Proposed Comment Resolution related to 127.2.6, 2.5GBASE-X PCS

**Comment #: 335~354 (DL), 228~233 (BM), etc
Pages 62~ 91 of D2.0 PDF (61~92 extracted)**

Edited by Yong Kim

Figure 127-2—Functional block diagram

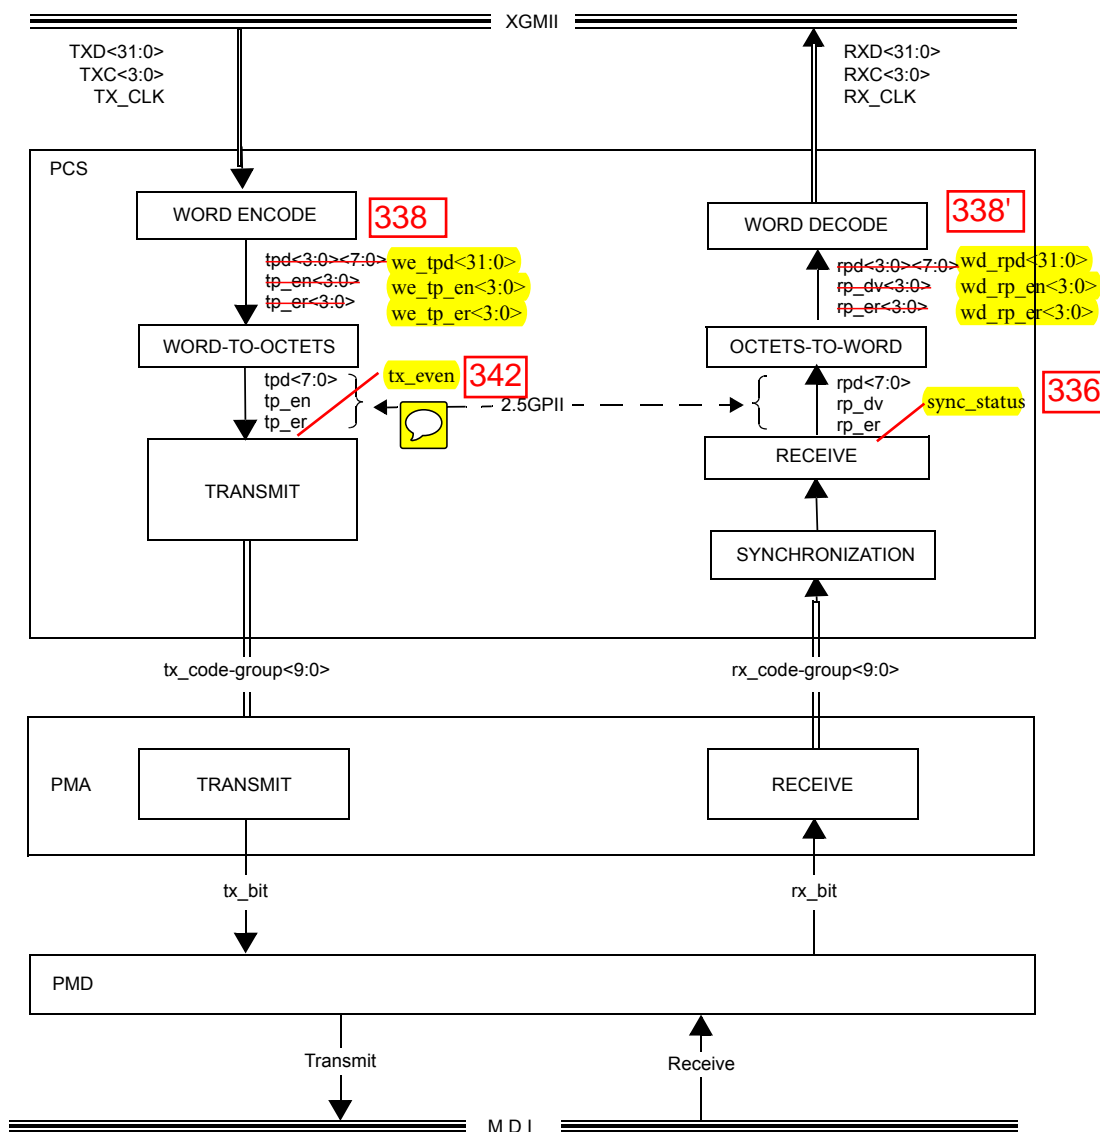
- 136 – DS – SIGNAL_DETECT – should be rejected (comment response says “proposed accept”).
- 335 DL – sync_status variable def correction.
- 336 DL – add tx_status to 2.5GPII interface in Fig 127-2 (and remedy seems to be wrong (refers to sync_status). So change to accept in principle.
- 337 – DL – Add values FAIL and OK definitions.
- 339 – DL – reference correction ... running disparity.
- 231 – BM – editorial “SUDI...EEE....”
- 232 – BM – 287 – CD - editorial “NEXTSEQ()
- 233 – BM – 137 – DS - editorial “Signal_de..” to “signal_de...”
- 340 - DL – TX_CLK on XGMII
- 341 - DL – Editorial improvements on 127.2.6.1
- 342 – DL – tx_even to 127-2
- 343 – DL – PCS Word Encode SD
- 346 – DL – IF THEN ELSE (capitalize)
- 3 – ML – Editorial Improvements on Fig 127-5 PCS TX State Diagram

Figure 127-4—PCS Word Encode and Word-to-Octets state diagram

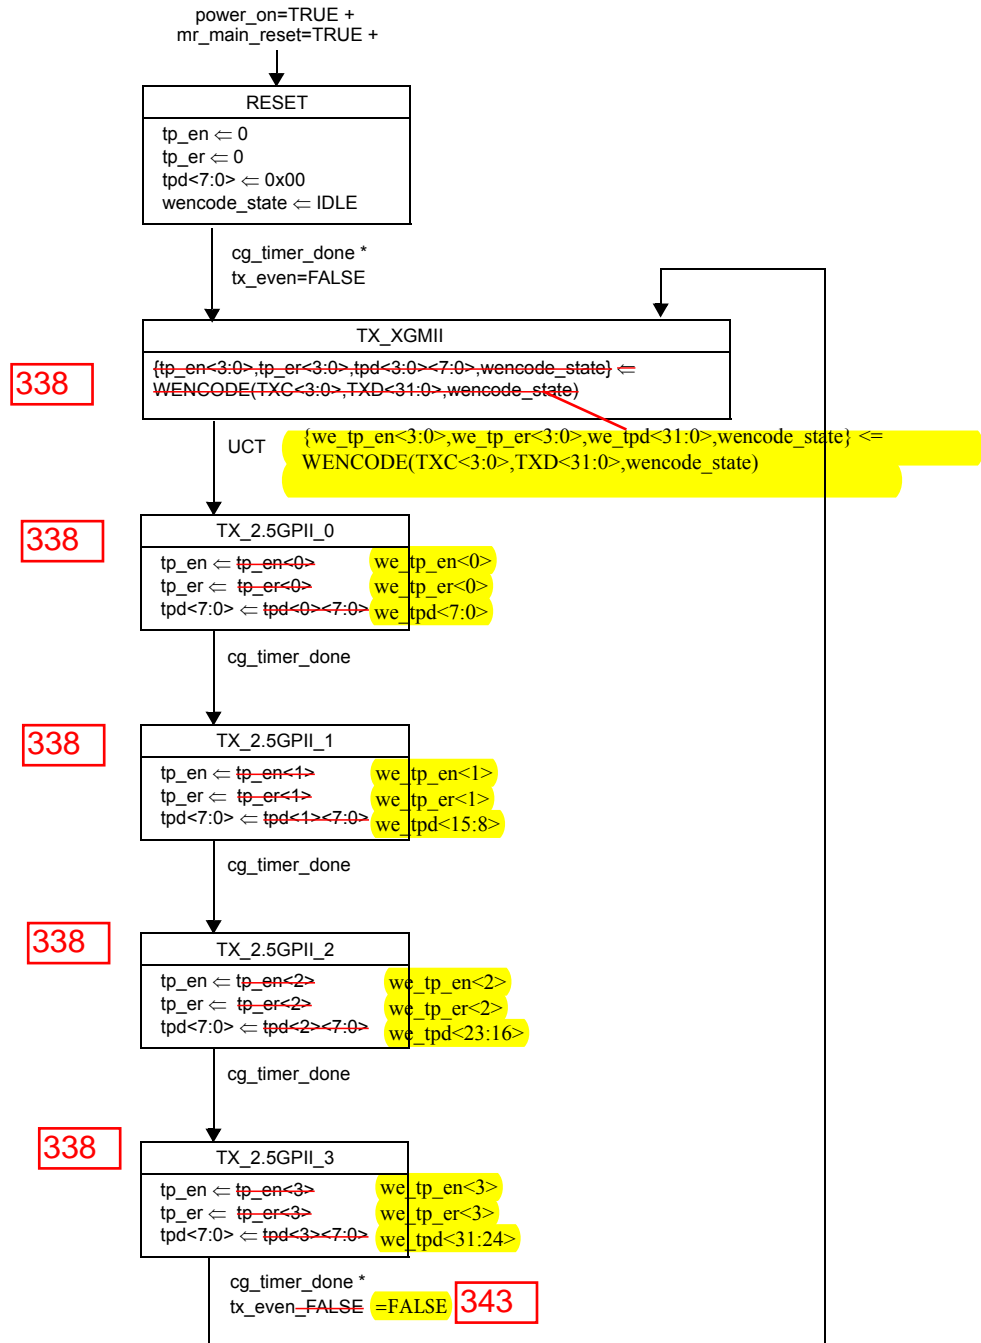
- 338 DL – rename `tp_en<3:0>`, `tp_er<3:0>`, `tpd<3:0><7:0>` to `we_tp_en<3:0>`, `we_tp_er<3:0>`, `we_tpd<31:0>` and 338' - likewise to RX path.
338'' – additional editorials to to help to clarify.

Figure 127-7—Synchronization state diagram

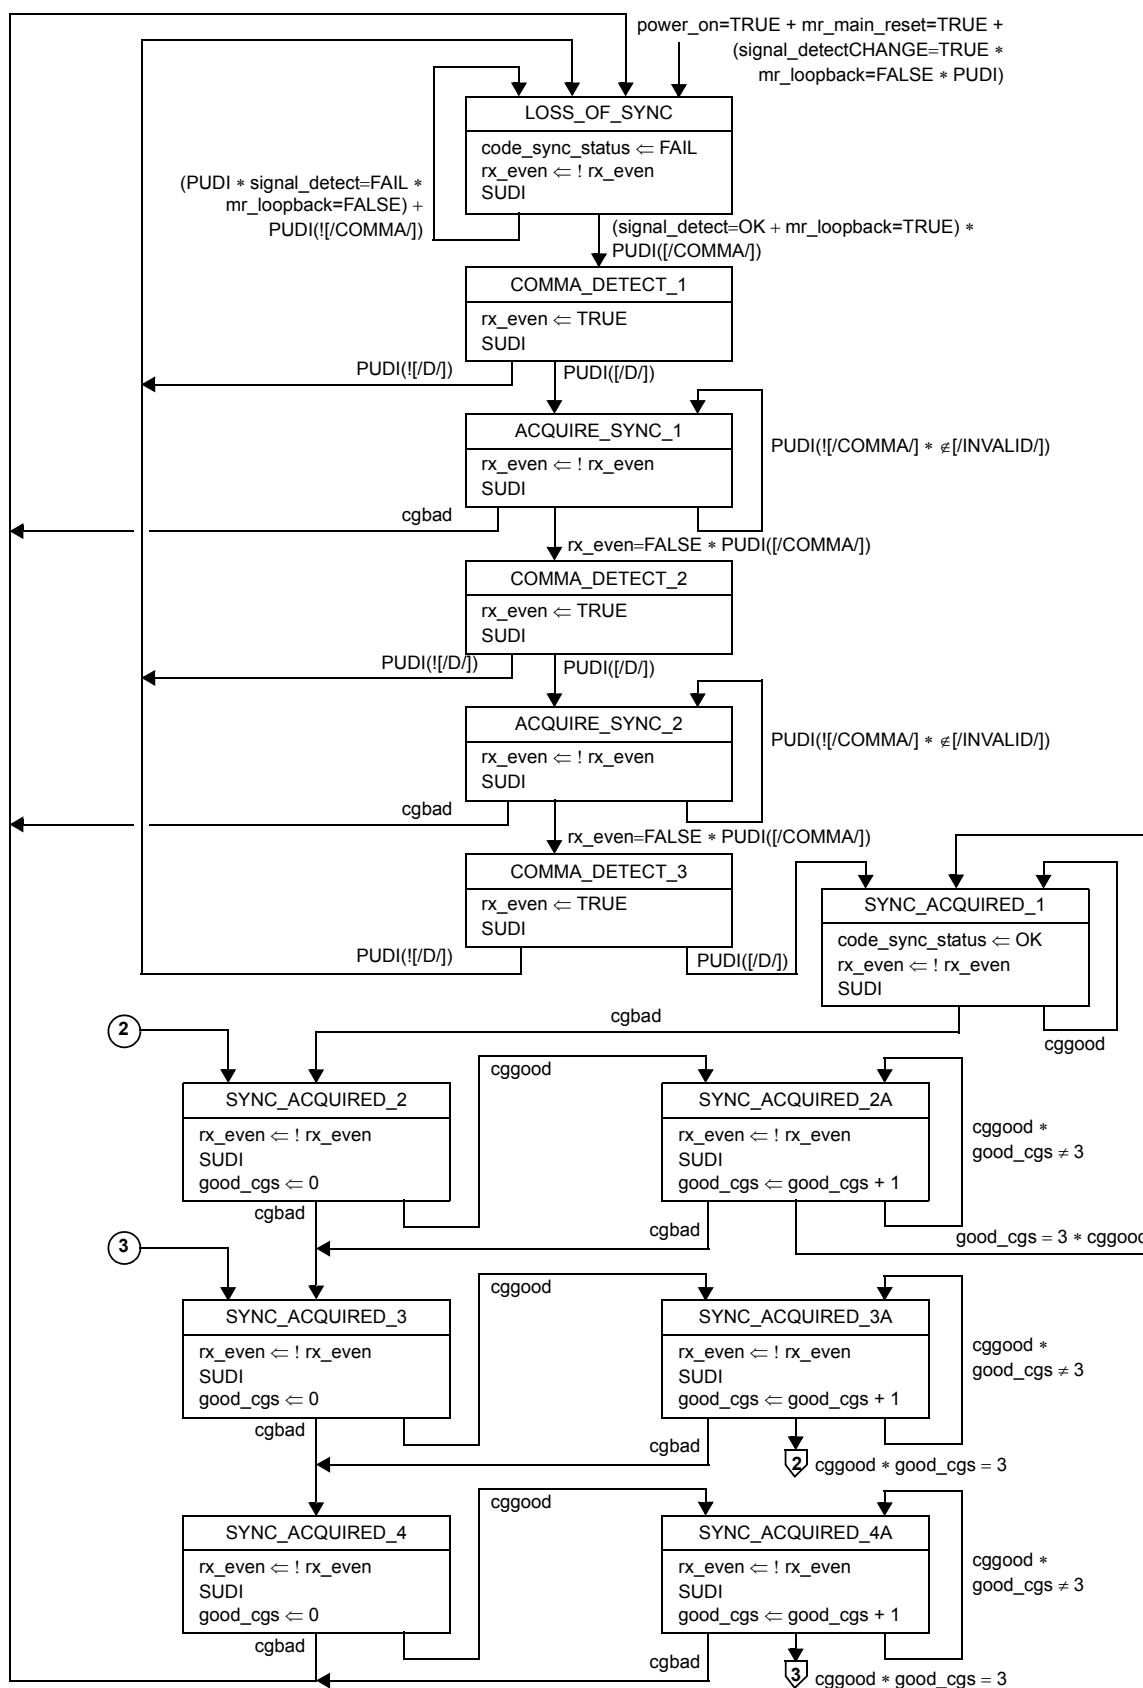
- 135 – DS – Effect/affect ?
- 347 – DL – sync_status and code_sync_status
- 348 – DL – rx_lpi_active
- 349 & 350 – DL – LINK_FAILED state. Delete ; ; .; WAIT_FOR_K state Delete ; .
- 351 & 352 DL – rp-dv rp_dv
- 353 DL – Note 2 to be added
- 4, 5 – ML – Clean up lines, corners, and arrows in Fig 128-8b
